ATTACHMENT "A"

### 3/4.1 REACTIVITY CONTROL SYSTEMS

8707230062 870717  
PDR ADDOCK 05000361  
PDR

ATTACHMENT "B"

**Figure 3.1-1**  
**MINIMUM STORED BORIC ACID VOLUME**  
**AS A FUNCTION OF CONCENTRATION**  
**(Gallons)**

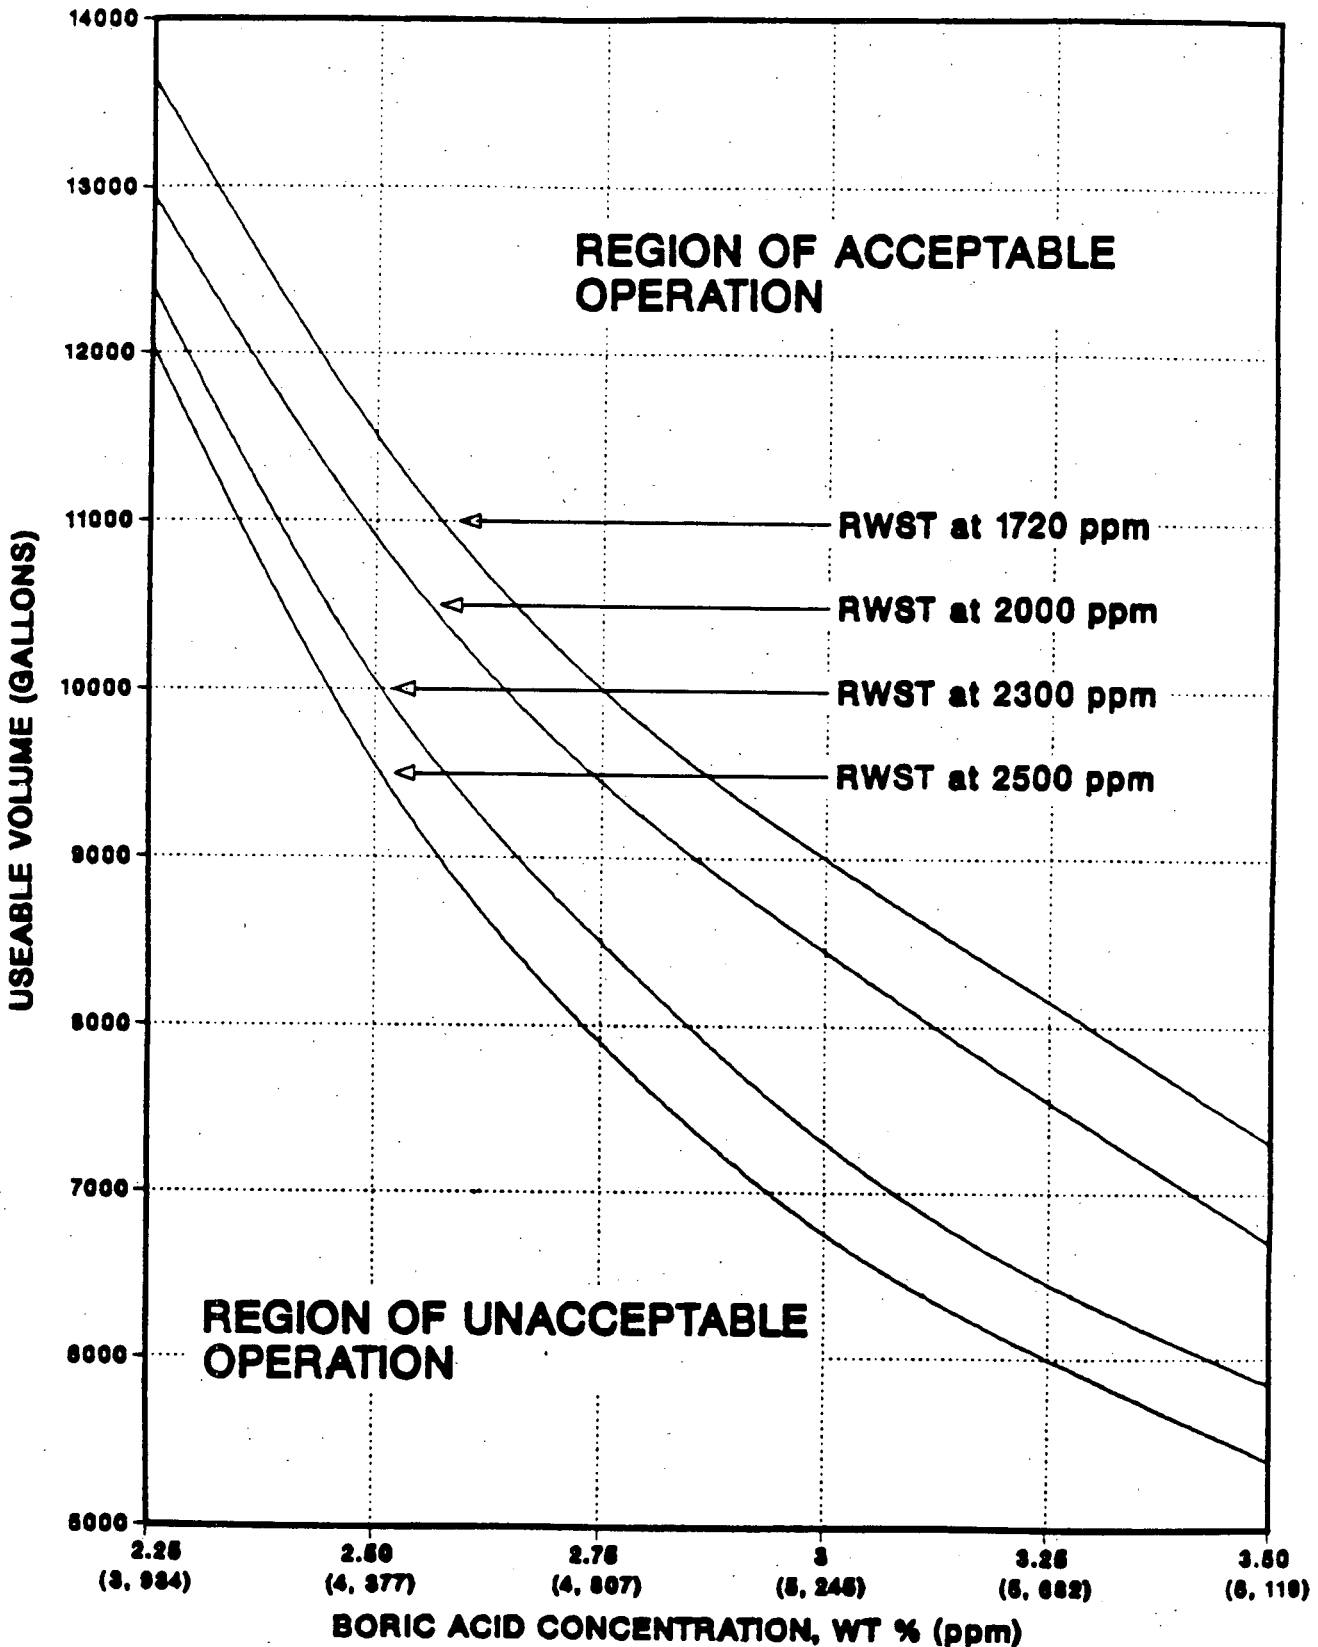
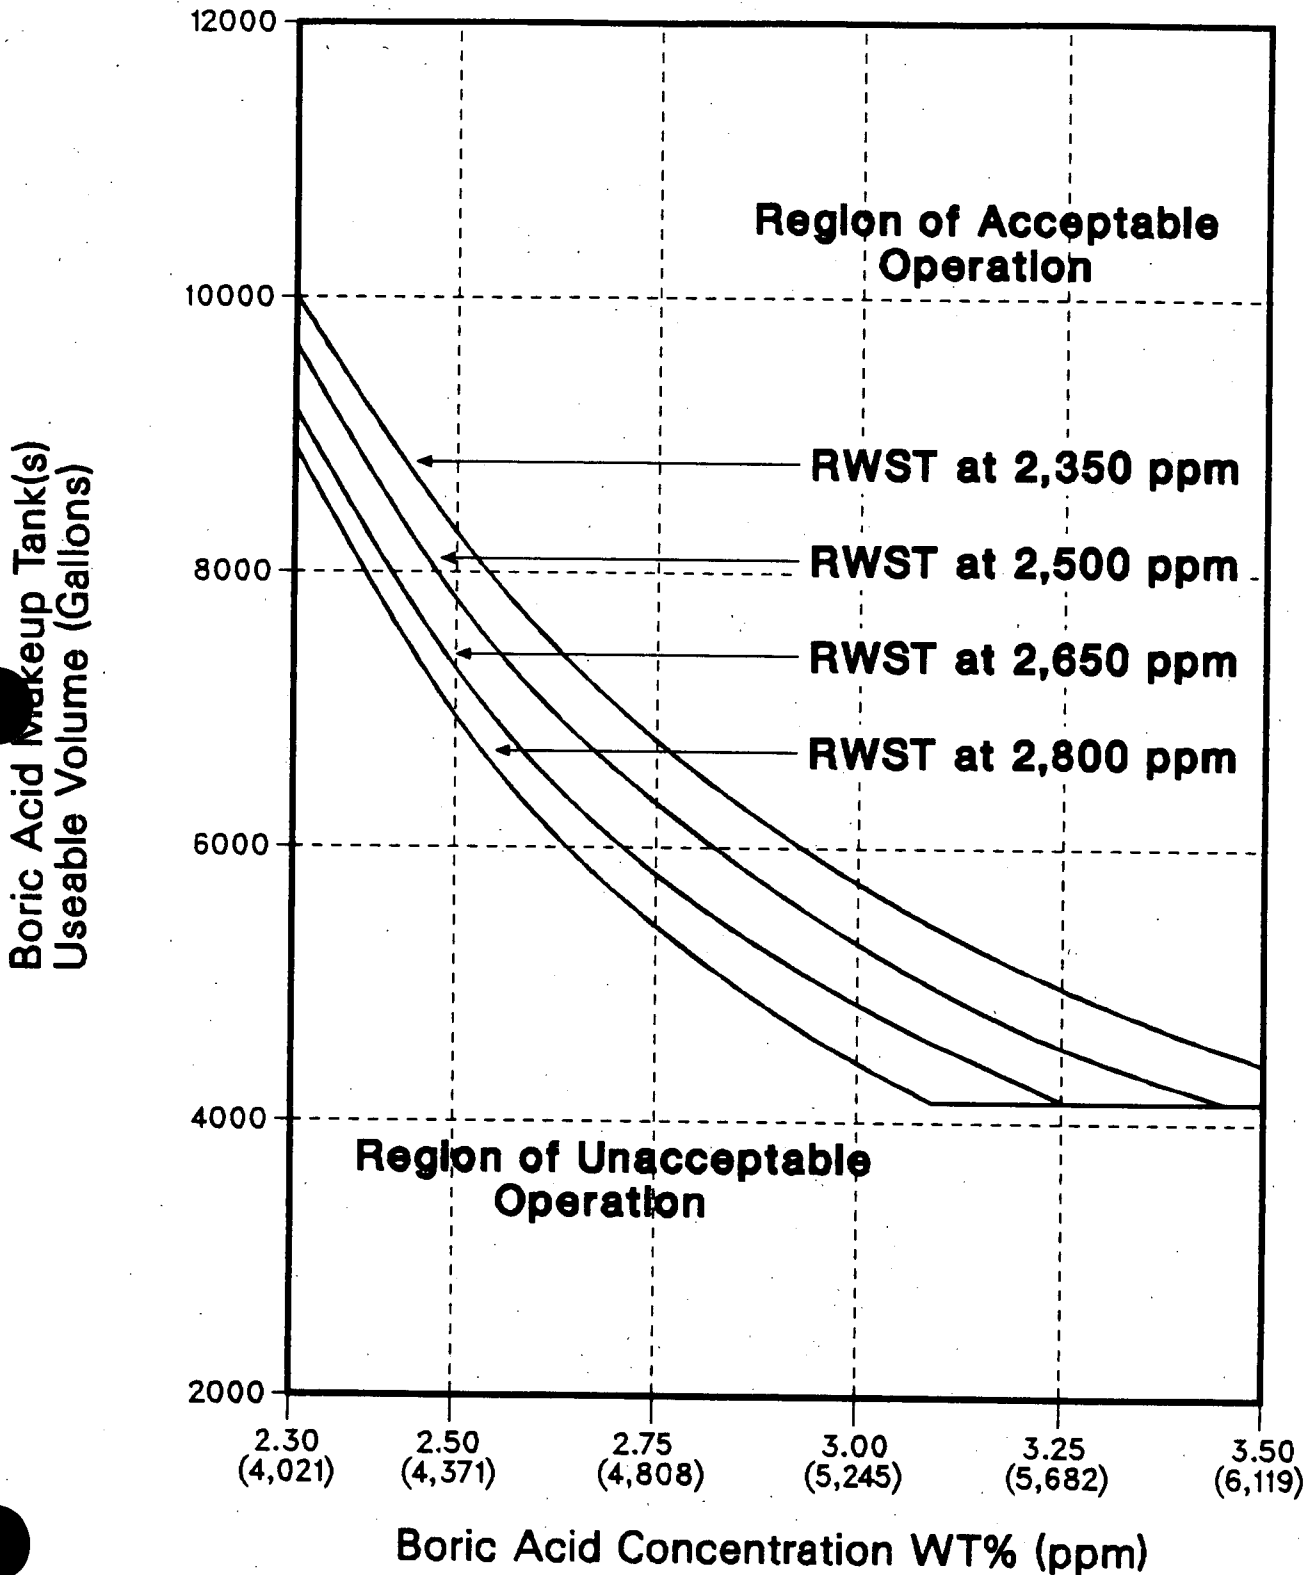
- a. One boric acid makeup tank with a minimum boron concentration of 2350 ppm and a minimum borated water volume of 4150 gallons, or
- b. The refueling water storage tanks with:
  1. A minimum borated water volume of 4150 gallons above the ECCS suction connection,
  2. A minimum boron concentration of 2350 ppm, and
  3. A solution temperature between 40°F and 100°F.

- 1) One boric acid makeup tank, with the tank contents in accordance with Figure 3.1-1, its associated gravity feed valve, and boric acid makeup pump,
- 2) Two boric acid makeup tanks, with the combined contents of the tanks in accordance with Figure 3.1-1, their associated gravity feed valves, and boric acid makeup pumps,
- 3) Two boric acid makeup tanks, each with contents in accordance with Figure 3.1-1, at least one gravity feed valve, and at least one boric acid makeup pump and,

The boron capability required below 200°F is based upon providing a 3% delta k/k SHUTDOWN MARGIN after xenon decay and cooldown from 200°F to 140°F. This condition requires 4150 gallons of 2350 ppm borated water from either the refueling water tank or boric acid solution from a boric acid makeup tank.

**Figure 3.1-1**  
**MINIMUM STORED BORIC ACID VOLUME**  
**AS A FUNCTION OF CONCENTRATION**  
**(Gallons)**

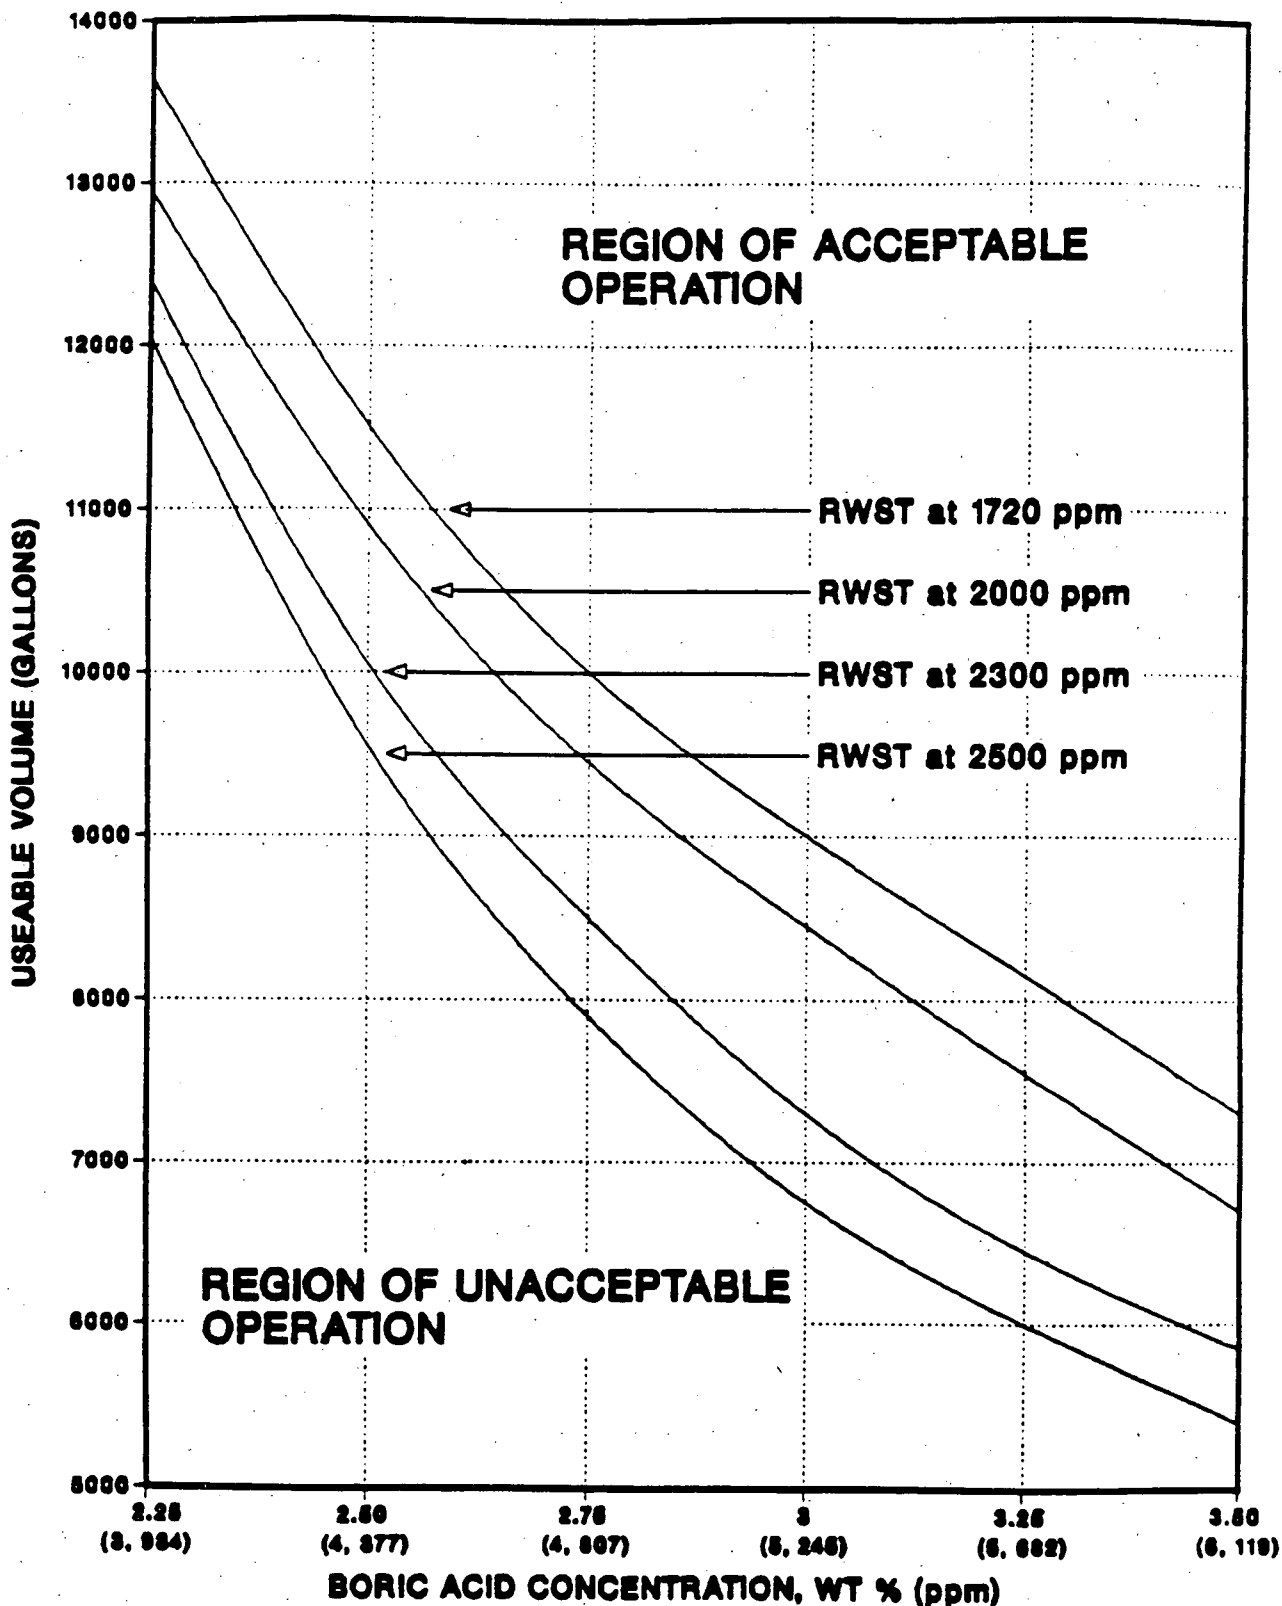
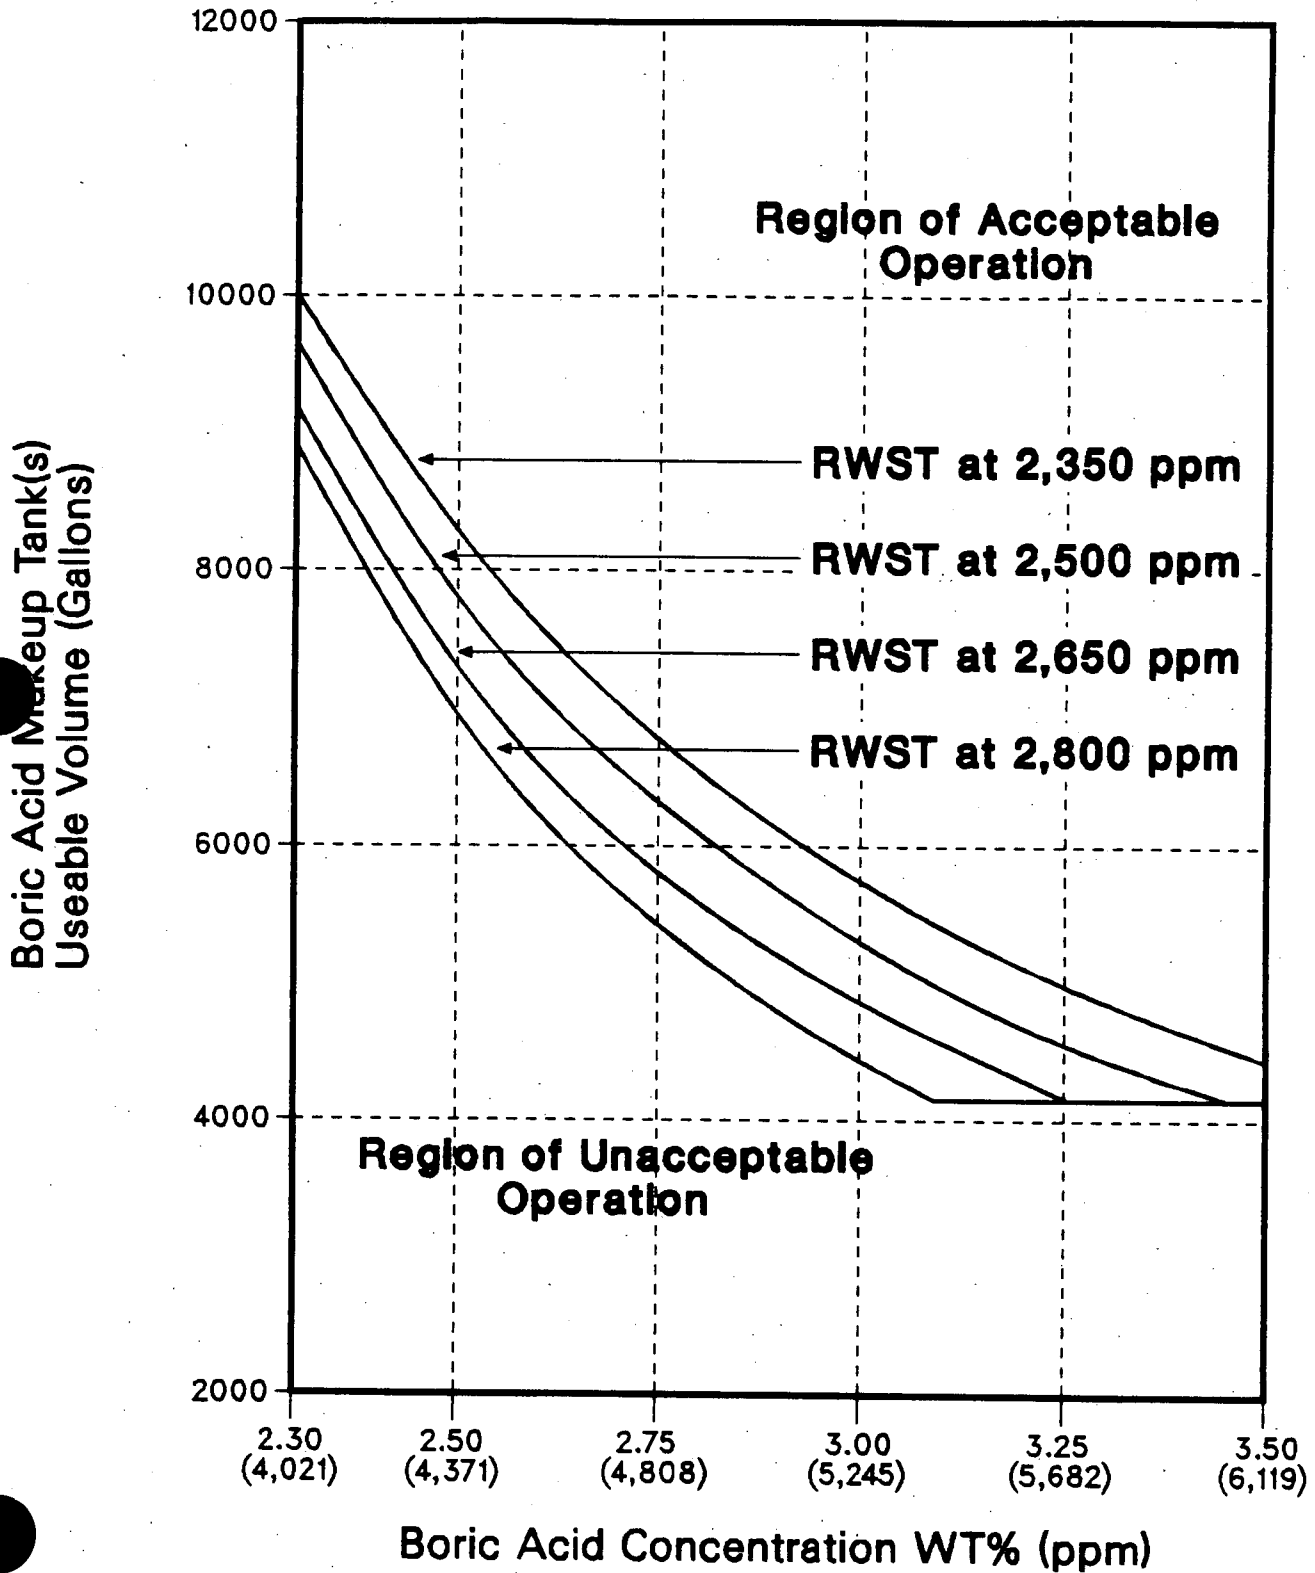
- a. At least one of the following combinations:
  - 1) One boric acid makeup tank, with the tank contents in accordance with Figure 3.1-1, its associated gravity feed valve, and boric acid makeup pump,
  - 2) Two boric acid makeup tanks, with the combined contents of the tanks in accordance with Figure 3.1-1, their associated gravity feed valves, and boric acid makeup pumps,
  - 3) Two boric acid makeup tanks, each with contents in accordance with Figure 3.1-1, at least one gravity feed valve, and at least one boric acid makeup pump and,
- b. The refueling water storage tank with:
  - 1) A minimum contained borated water volume of 362,800 gallons above the ECCS suction connection,
  - 2) Between 2350 and 2800 ppm of boron, and
  - 3) A solution temperature between 40°F and 100°F.
